ADDENDUM NUMBER 3

Nanuet 2020 Miller Hydronic Conversion

PROJECT NUMBER | 1911002.00 Delta Engineers Number 2019.229.001

Date | 4/7/2021

MES-M601

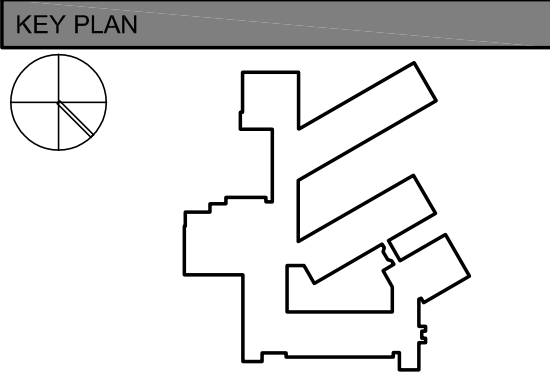
- a. Sheet MES H601: Added notes requirements for the fan coil units AHU-1 & 2 in the gym. Replaced Sheet.
- b. Sheet MES E101 Deleted field installed disconnect. Replaced Sheet.
